RFQ 2023-002-1007
Hellen Haller Elementary School
Fire Alarm Replacement

Sequim School District #323

ADDENDUM 1

Issued: March 24, 2023

A4
 OF 8 SHEETS

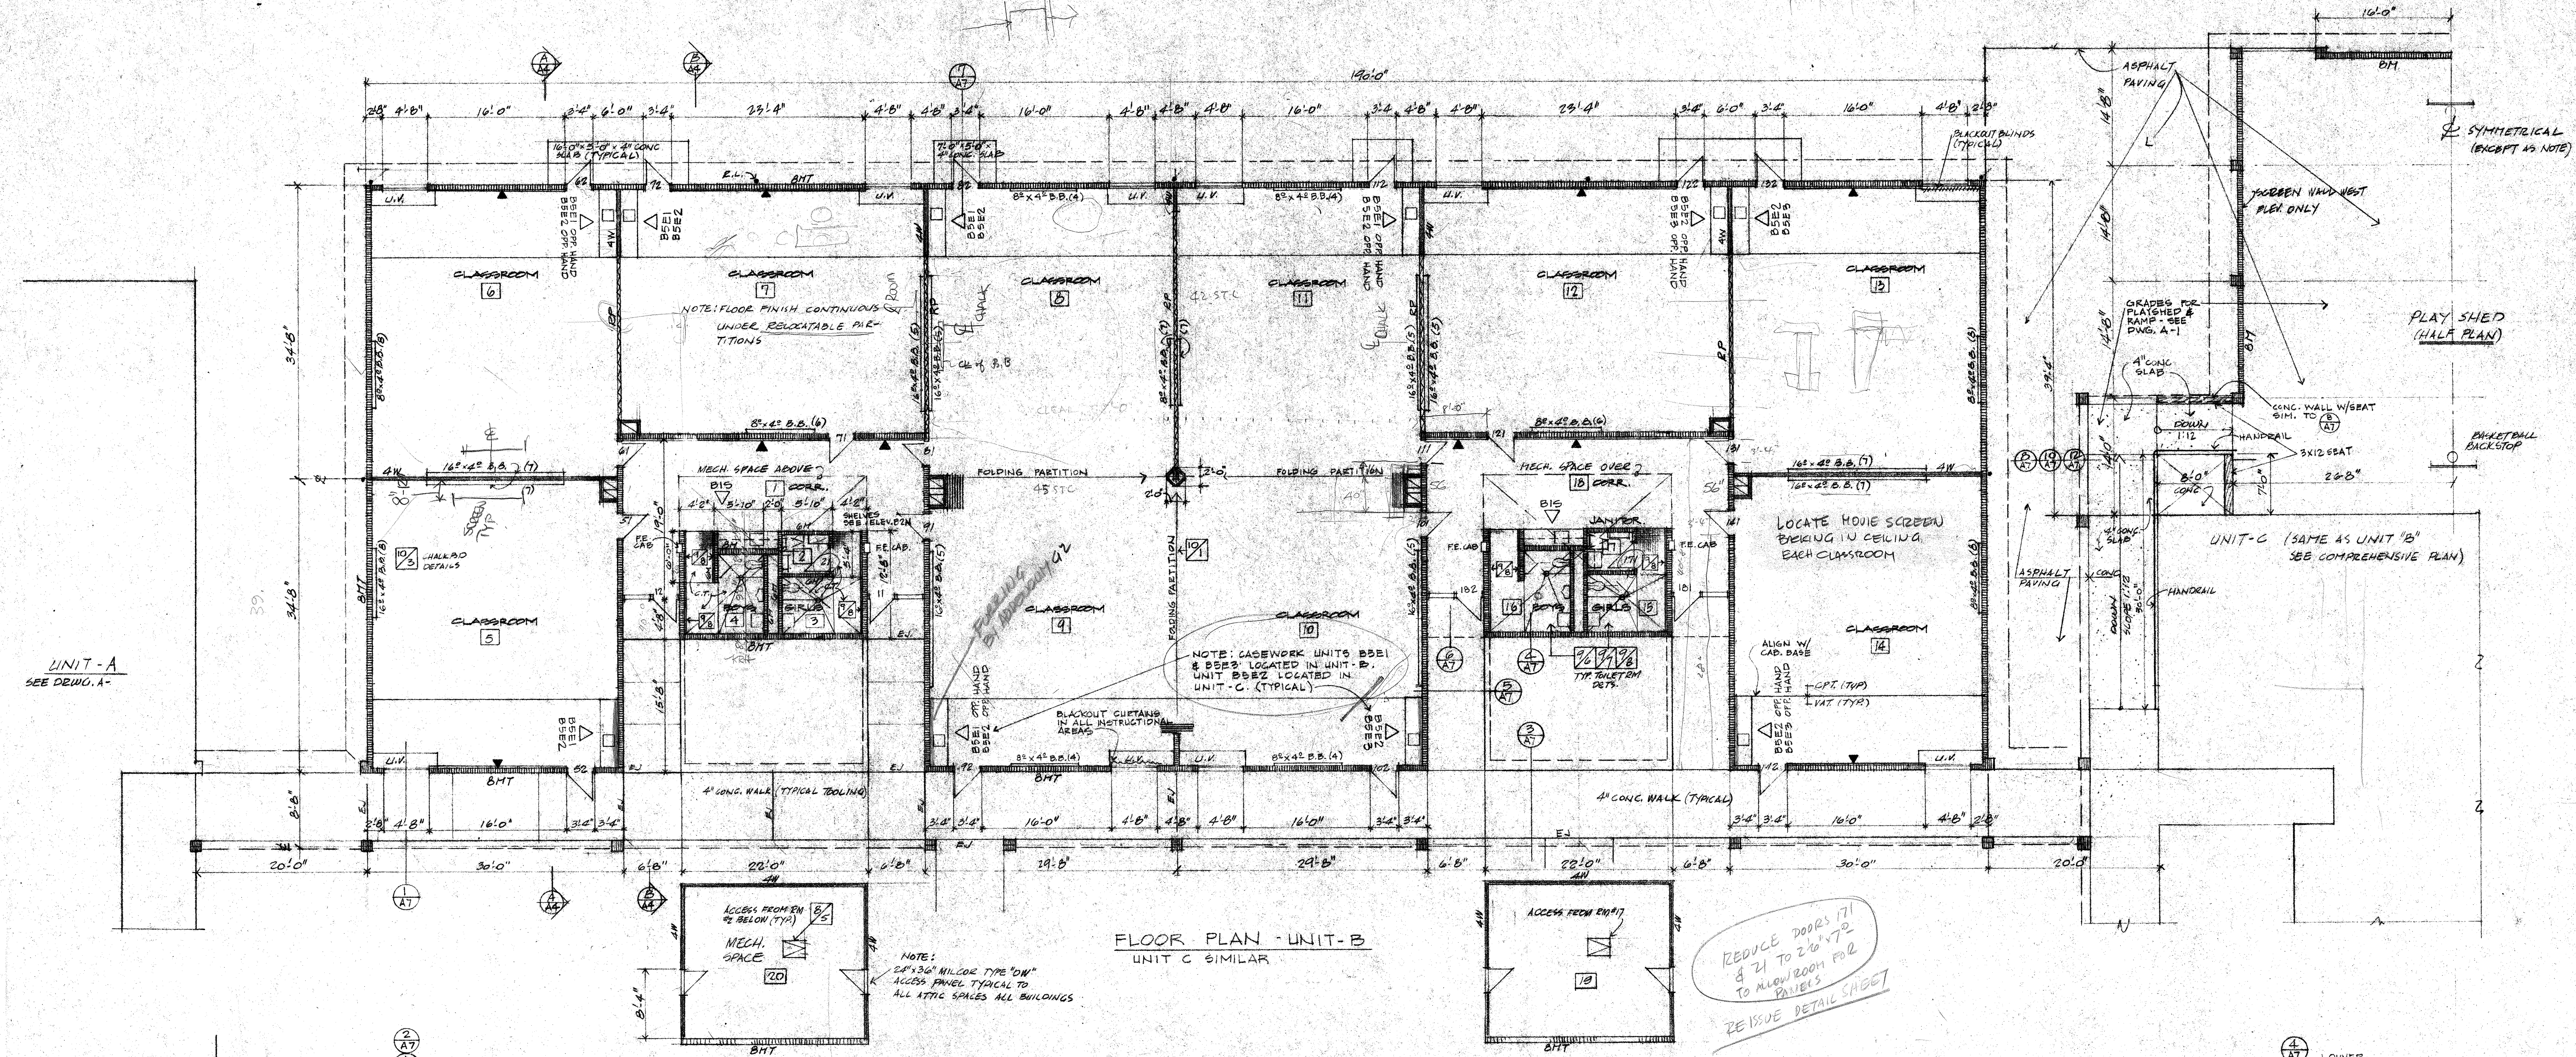
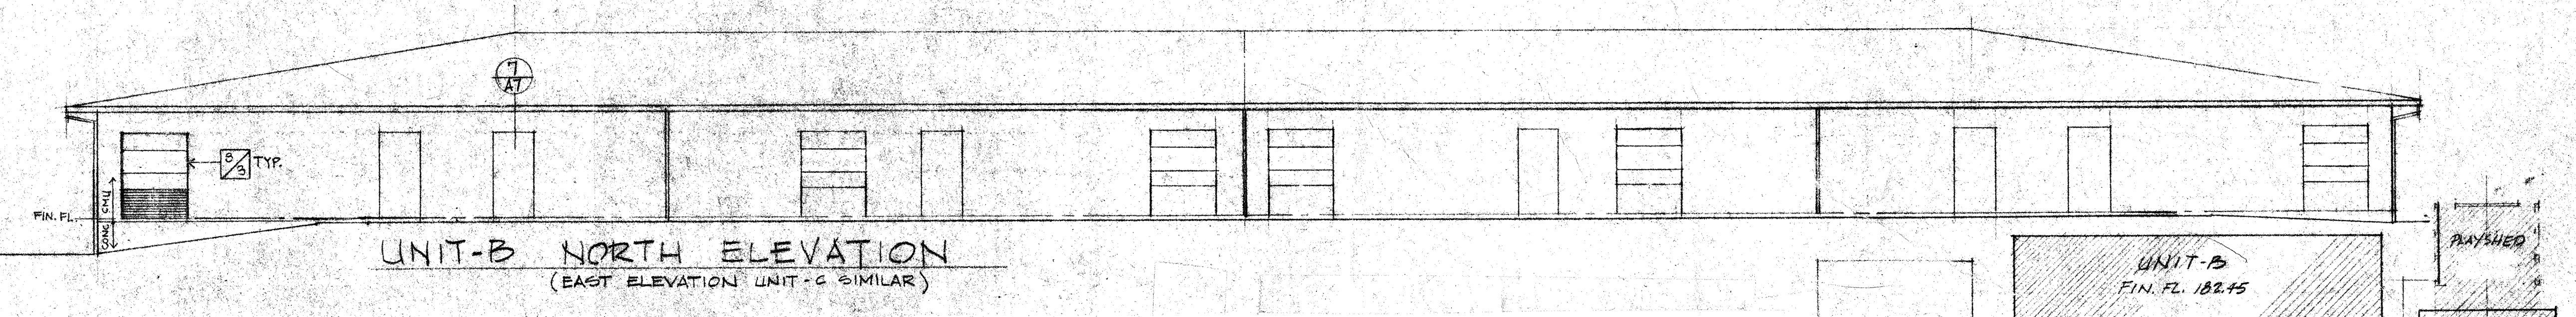
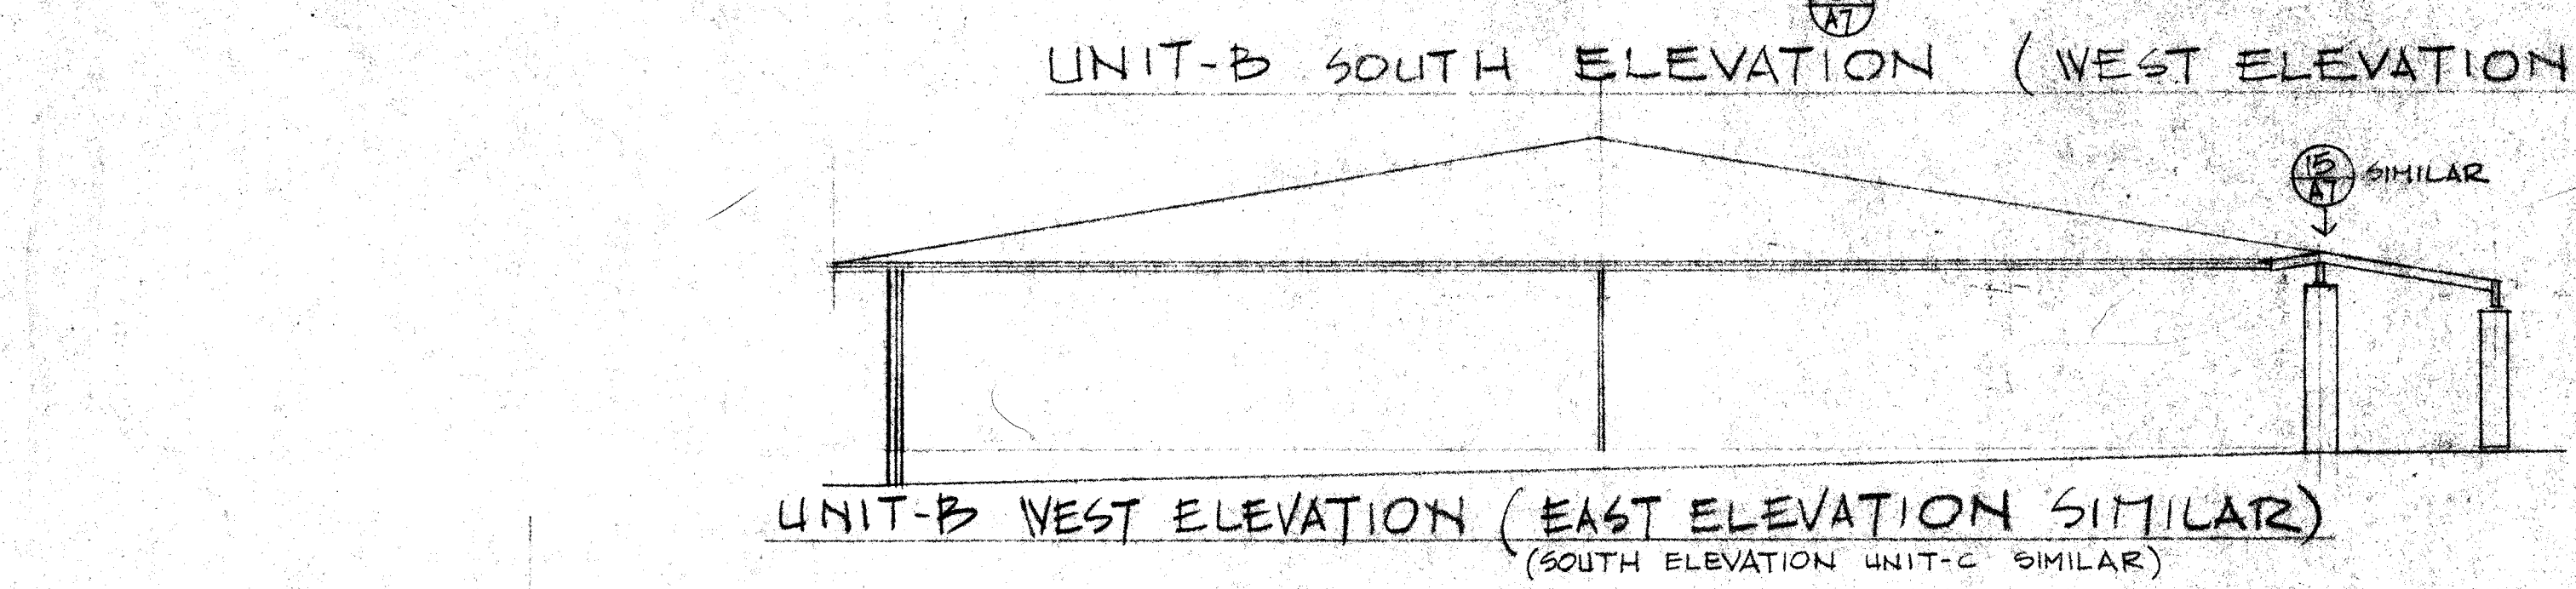
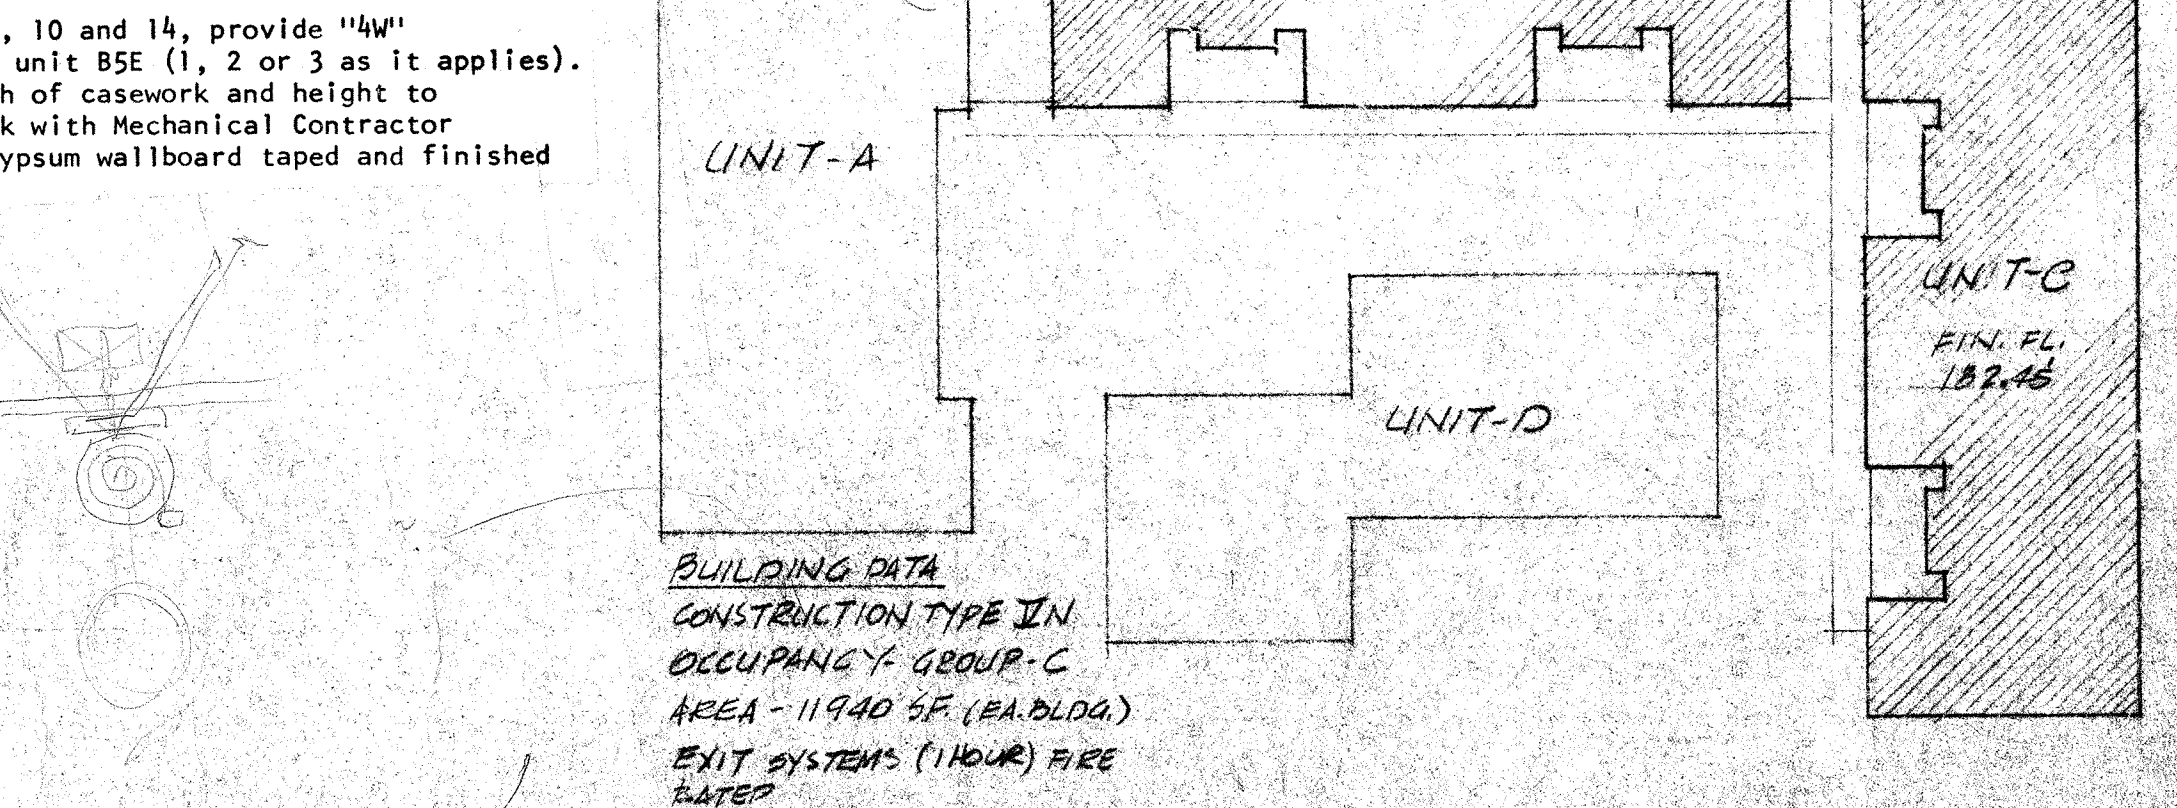
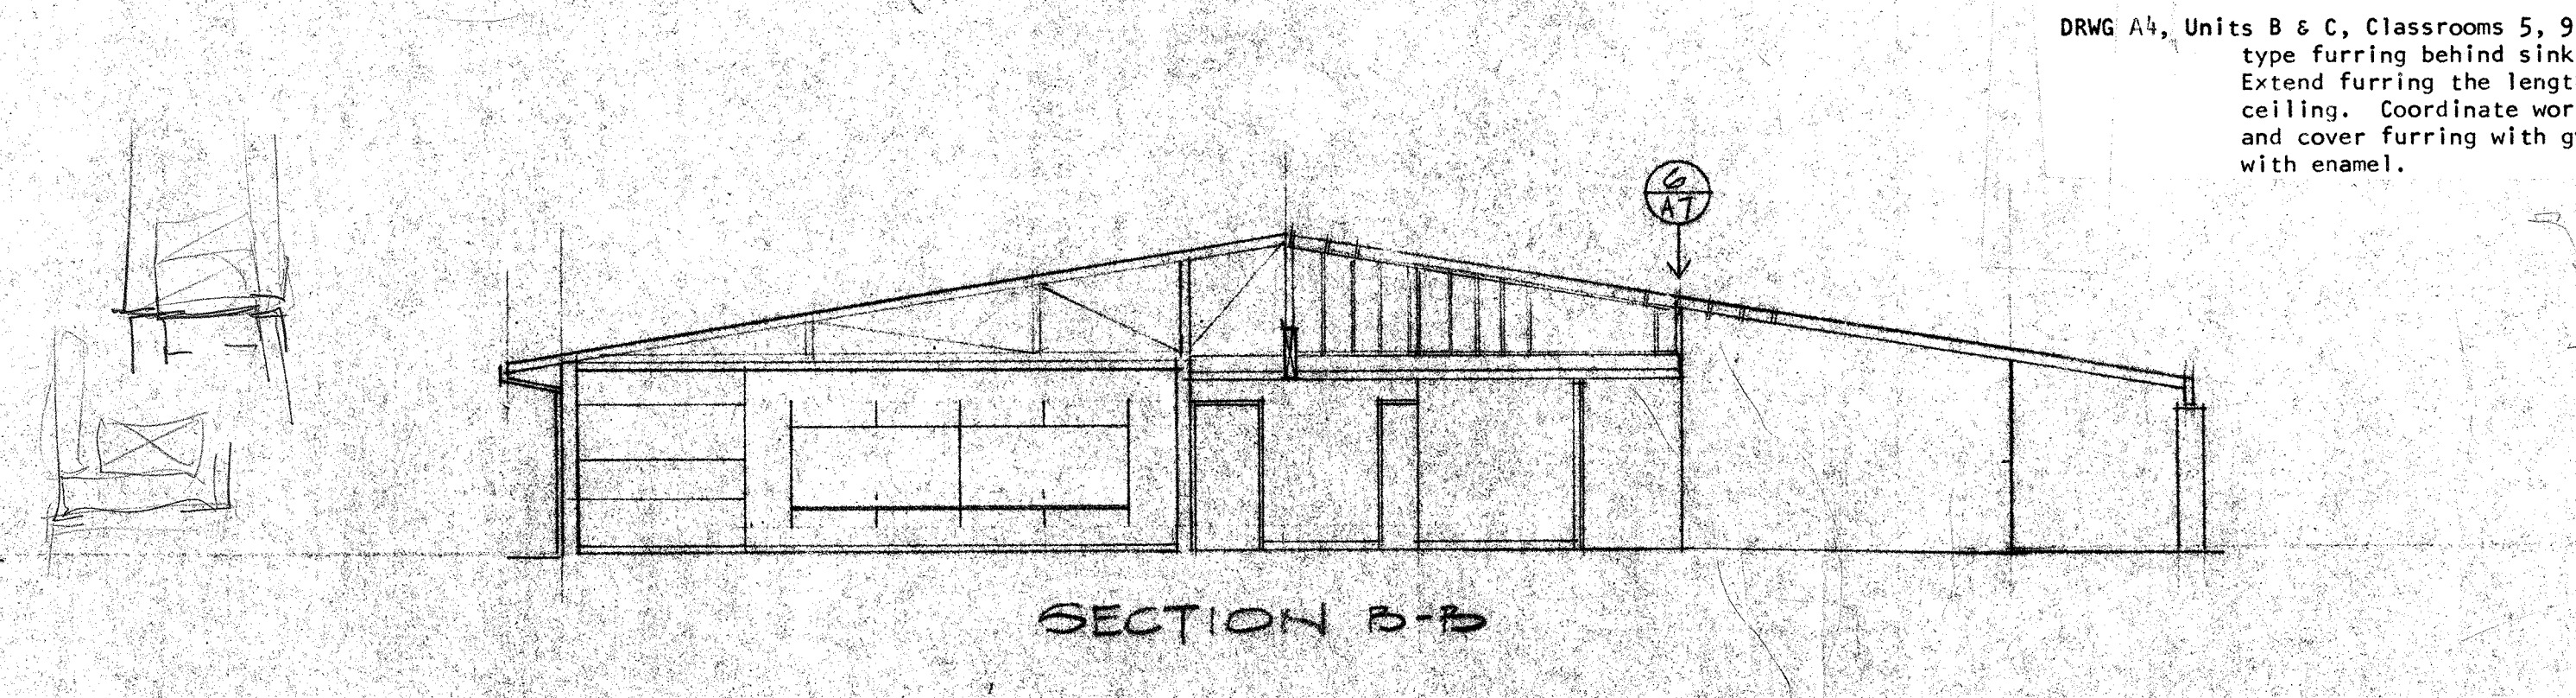
DRWG A4, Units B & C, Classrooms 5, 9, 10 and 14, provide "W" type furring behind sink unit BSE (1, 2 or 3 as it applies). Extend furring the length of casework and height to ceiling. Coordinate work with Mechanical Contractor and cover furring with gypsum wallboard taped and finished with enamel.
